PROJECT REVIEW - CONSULTATION NOTICE

Subject: **General Plan Amendment No. GPA 20-009** for the County of Tulare to amend the 2017 Animal Confinement Facilities Plan ("ACFP") and 2017 Dairy and Feedlot Climate Action Plan ("Dairy CAP"), regulating new dairies and dairy expansions located in the unincorporated areas of Tulare County. The 2017 ACFP, 2017 Dairy CAP, and the 2017 Final Environmental Impact Report ("FEIR") for the 2017 ACFP and Dairy CAP are available at the following link: <https://tularecounty.ca.gov/rma/index.cfm/permits/dairy/>. GPA 20-009 proposes to: 1) reduce the 2017 ACFP "streamlining" screening level for dairy expansions (Policy 2.5-3 of the 2017 ACFP) to no more than once every five years, 2) reduce the 2017 ACFP "streamlining" screening level for dairy expansions listed in the Conformance Checklist Criteria in Appendix A to the 2017 ACFP from 25,000 MT of CO₂e per year to 15,000 MT of CO₂e per year, and 3) move certain GHG emission reduction strategies from Category B to Category A in the Dairy CAP.

Proposed 2020 ACFP Amendment

Proposed 2020 Dairy and Feedlot CAP Amendment

Figure 1. Flow Chart Illustrating Method of Determining Required Level of Analysis for CEQA for Facility Expansions.

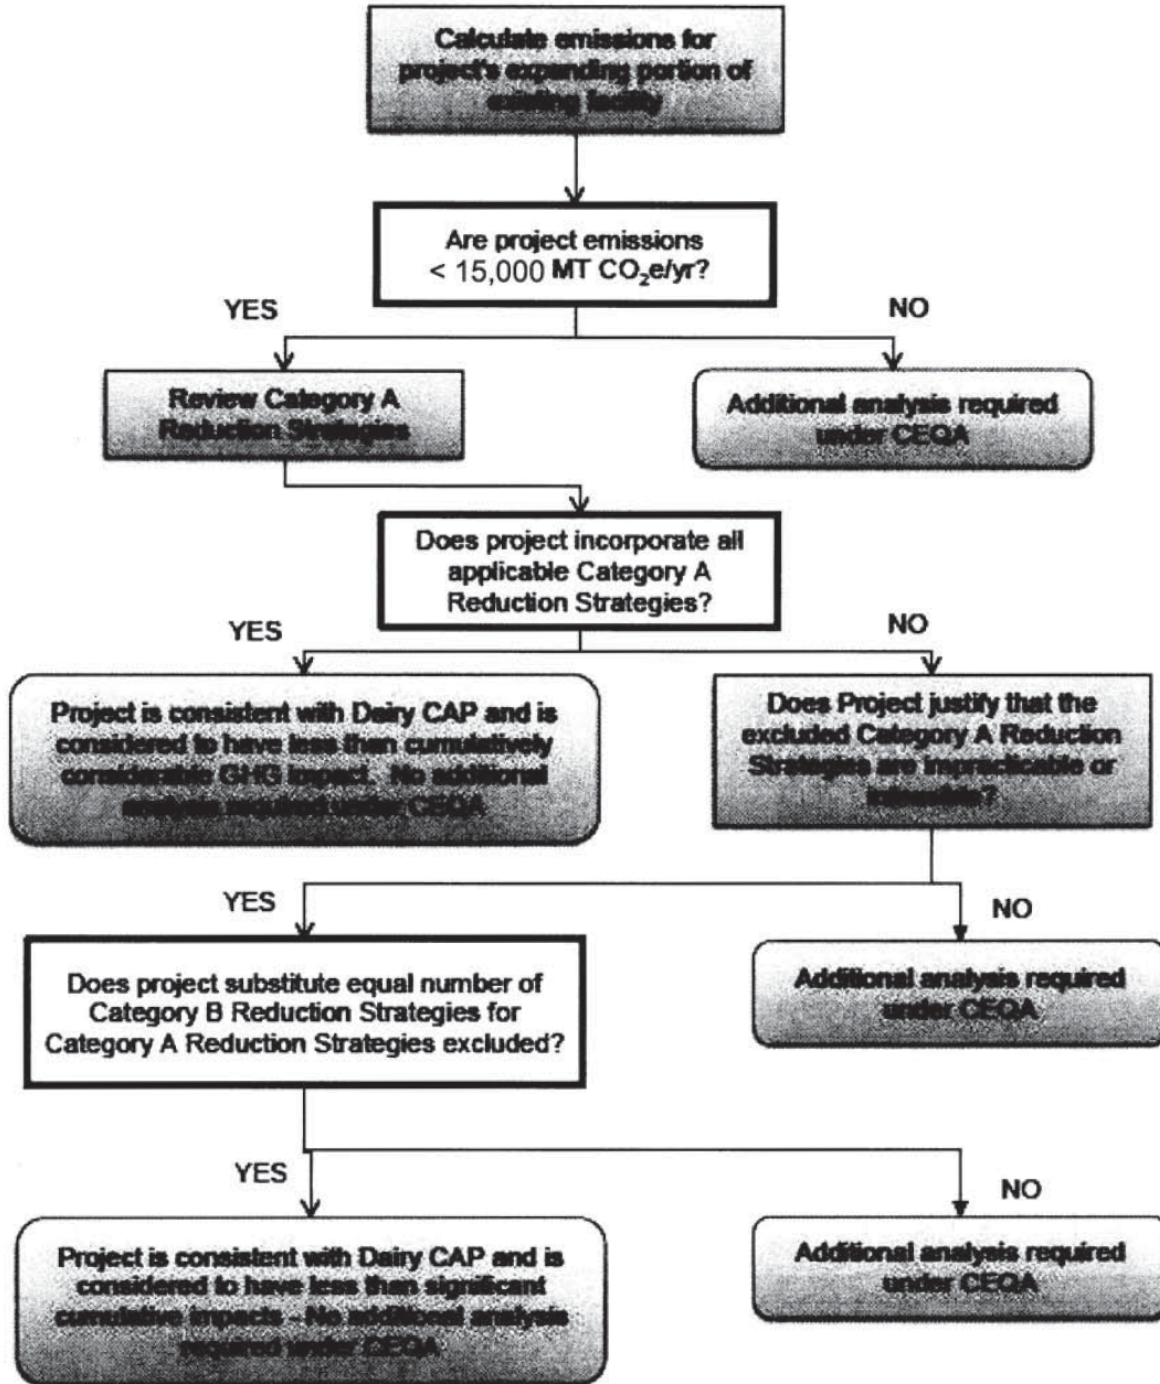
(G) Figure 1 of Section 7 Future Project GHG and Climate Change Evaluations of the 2017 Dairy CAP is amended to read as set out below:
